Our Ref: J-2938 W 03 JC
12th November 2010

Re: Development at Carwin Rise – Groundwater Levels at Loggans Moor SSSI

Pre-Development Peak Runoff

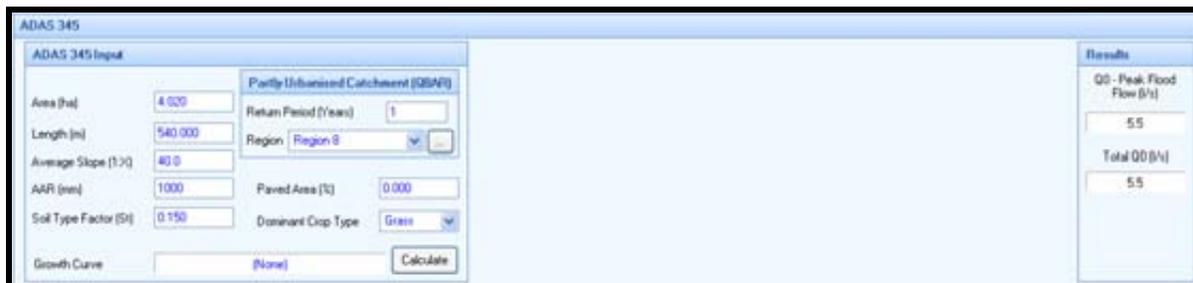
Your specific concerns were as follows 'Our concern centers round the fact that the water levels at the site will presumably be lowered by the introduction of drainage under the pitches and elsewhere, and whether that will affect ground water levels at the Loggans Moor SSSI. We assume that because the rainfall onto the large area of pitches will be partially intercepted by the drainage under them, groundwater re-charge may be significantly reduced, particularly since water drained from the site is unable to permeate back into the soil down the swale. If ground water levels in Loggans Moor are consistently higher than the adjacent rugby pitch, it seems logical that they will gradually dry out. What we are looking for is a comprehensive, clear explanation of why that is not the case. We are also not certain of the role that the intervening A30 road would play in all this'.

From the ADAS assessment it can be seen that the runoff rate from the site will reduce from a peak rate of 5.5 l/s to 3.4 l/s; this is a reduction of around 38%. Therefore it would be fair to make the assumption that the amount of water entering the ground would increase by around 38%. Clearly then, as a result of terracing the development site the rate of groundwater re-charge would significantly increase.
